Access Compliance Report Public Rights-of-Way (Curb Ramps)

Main Street: **MERCANTILE_WAY** Cross Street: **N/A** Location: **NE**

ADA ID: **RPRK211102113232** Ramp Type: **Type 1 - Perpendicular Diagonal** Initial Pass/Fail: **Fail** Overall Compliance: **No** Severity Score: **2**

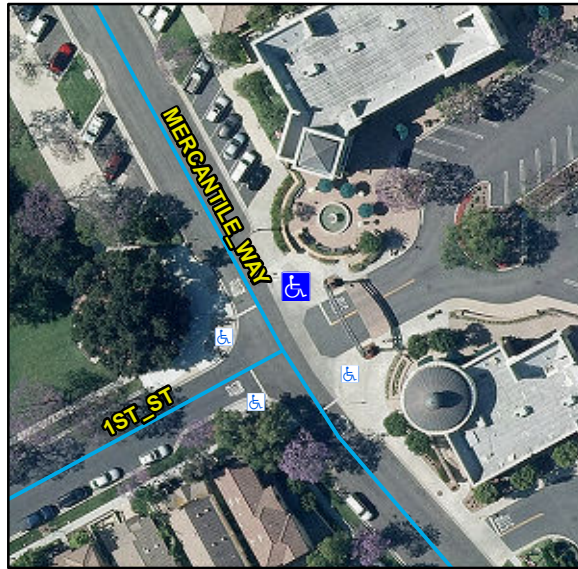
Compliance	Description	Data	Compliance	Description	Data
N/A	Ramp Length (in)	116	N/A	Flare Type LT	
Yes	Ramp Width (in)	48			N/A
Yes	Ramp Run Slope (%)	7	N/A	Flare Slope LT (%)	N/A
No	Ramp Cross Slope (%)	2.1	N/A	Flare Traversable LT	N/A
N/A	Landing Present	N/A	N/A	Flare Type RT	
N/A	Landing Length (in)	N/A			N/A
N/A	Landing Width (in)	N/A	N/A	Flare Slope RT (%)	N/A
N/A	Landing Run Slope (%)	N/A	N/A	Flare Traversable RT	N/A
N/A	Landing Cross Slope (%)	N/A	N/A	DWS Provided	N/A
N/A	Landing Movement Obstructed?	N/A	N/A	DWS Contrast	N/A
	Landing Movement Type	N/A	N/A	DWS Length (in)	N/A
N/A	Landing Shared	N/A	N/A	DWS Full Width	N/A
N/A	Clear Space	Yes	N/A	DWS Offset Left (in)	N/A
N/A	Clear Space To Crosswalk (in)	N/A	N/A	DWS Offset Right (in)	N/A
N/A	Marked Crosswalk 1	No	N/A	Marked Crosswalk 2	No
	Crossing 1 Direction	W		Crossing 2 Direction	S
	Marked Crosswalk 1 Width (in)	N/A		Marked Crosswalk 2 Width (in)	N/A

N/A	Ramp Inside Crosswalk 1	N/A	Yes	Ramp Inside Crosswalk 2	N/A
	Crossing 1 Slope (%)	0		Crossing 2 Slope (%)	1.1
	Crossing 1 Cross Slope (%)	0.7		Crossing 2 Cross Slope (%)	4
N/A	Gutter Ponding	N/A	No	Curb Slope	9.7
Yes	Gutter Lip Height (in)	0		Road Run Slope (%)	1.6
N/A	Gutter Run Slope (%)	N/A		Road Cross Slope (%)	5.1
N/A	Gutter Cross Slope (%)	N/A			
Yes	Overall Surface Condition: Acceptable		Yes	Perp Joint Present	Yes
	Cross Gutter Present?	Yes		Spandrel Present?	Yes
	Replace Cross Gutter?	No		Replace Spandrel?	No

Remove & Replace Curb Ramp With Two New Directional Ramps or Equivalent.
